Arboricultural Survey and Impact Assessment

Dukes Field Cottage – School House Application

Wokingham Borough Council Comments 18th October 2024

Response to Wokingham Council Tree Officer comments Received October 18th 2024.

APPENDIX 3: TREE SURVEY AND CONSTRAINTS PLAN

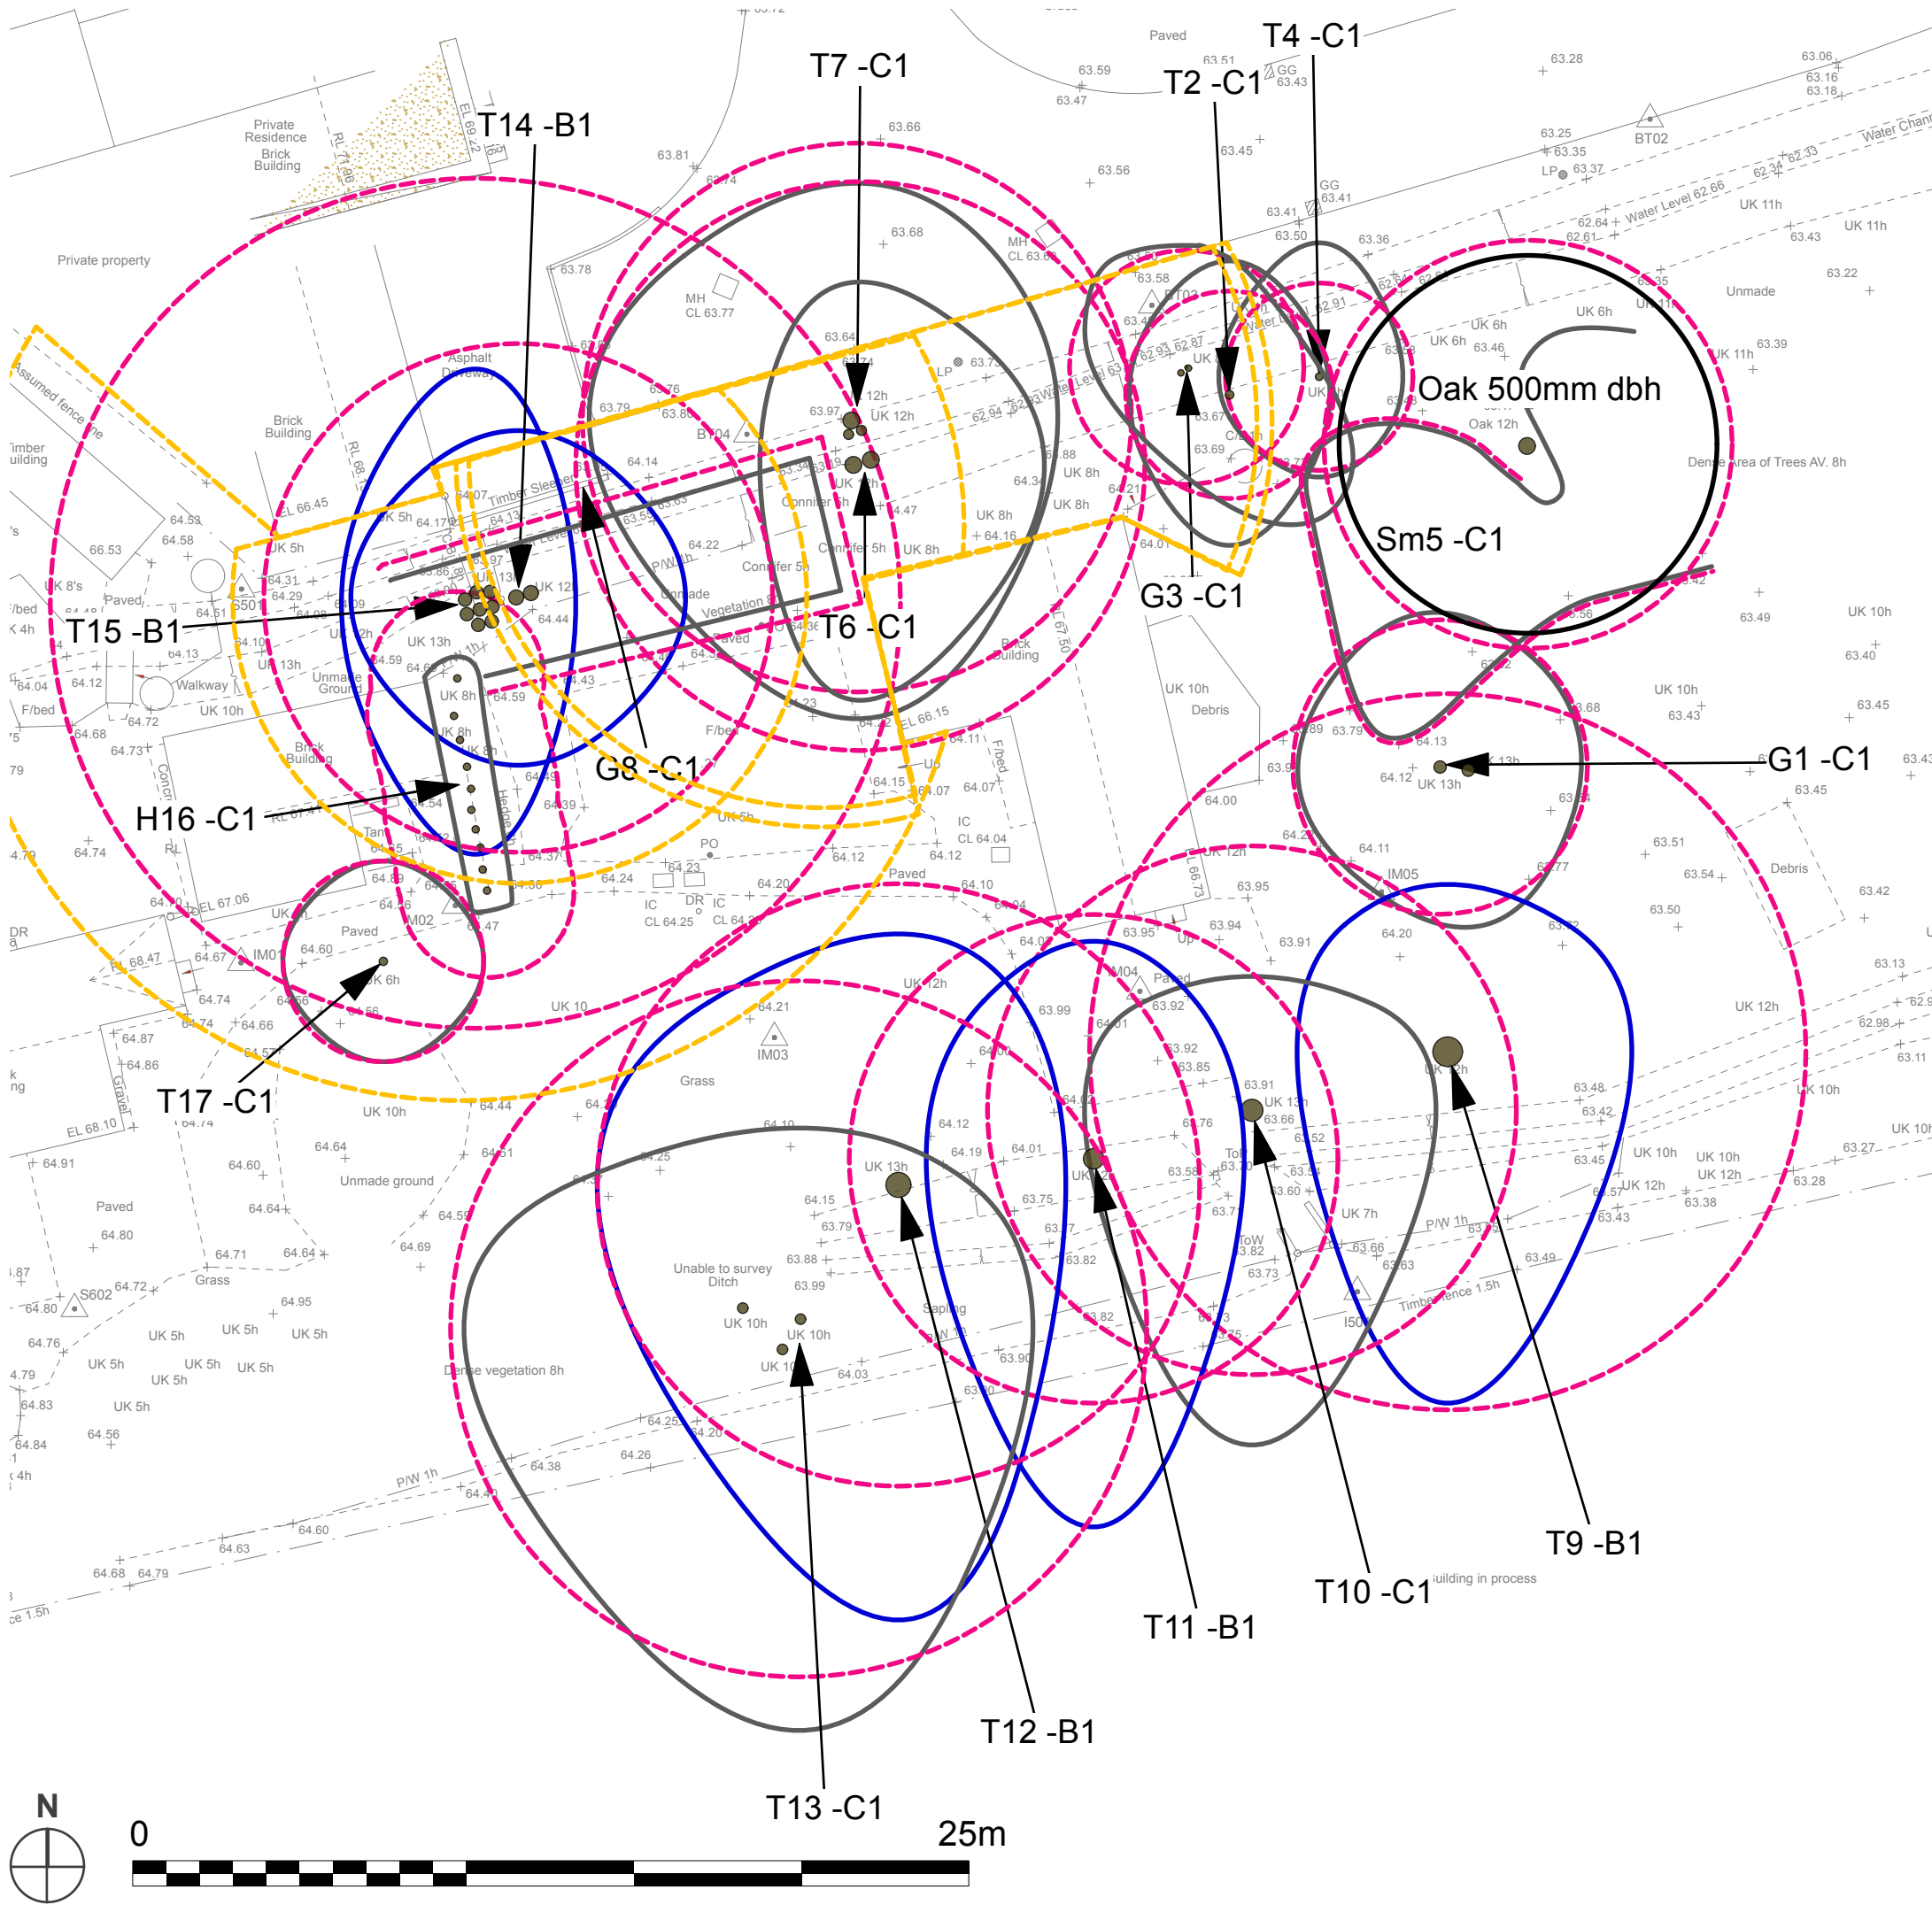
'Our landscape and trees officer finds that the arboricultural submissions have erroneously not adjusted the root protection area of trees for the root impermeable surfaces within and outside the site. It seems likely that the roots of T14, T15, T6 and T7 are within the site and that more than 20% of those will be in the area of built form.'

- 8.27 The tree survey and retention and loss and protection plans have been updated to include adjusted RPAS for T6, T7, T14 and T15. This reports author does not agree

that all roots from these trees will not have grown under the cul de sac surfacing to the north. The trees are sizeable stems growing close to the road. It is simply not true to say that not a single root would be supporting these trees and not growing beneath the roadway in the cul de sac. To show willing, the RPAs have been adjusted so that they run to the back of the kerb edge, and are adjusted to extend further into the site. The existing school house has a deep concrete foundation and this has also been considered when adjusting the RPA, to exclude roots from this area also, extending roots into the site and avoiding this area. The school house is therefore considered as existing hard surfacing.

Illustrative pile foundation detail for planning stage showing root interaction. (NTS)

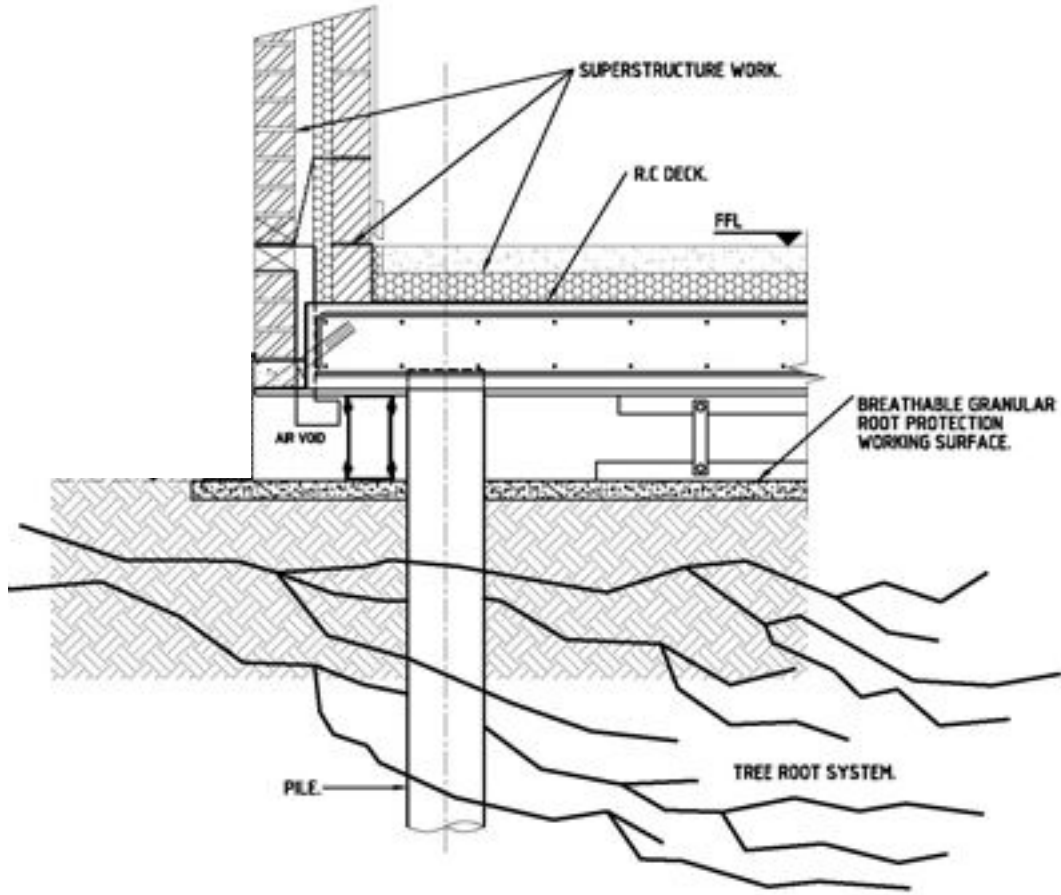
Tree Officer Note: Downpipes around the house allow water to the ground beneath the house

- 8.25 The architects have provided an indicative pile detail (appendix 6) and a method for screw piling is also included from a known pile contractor.
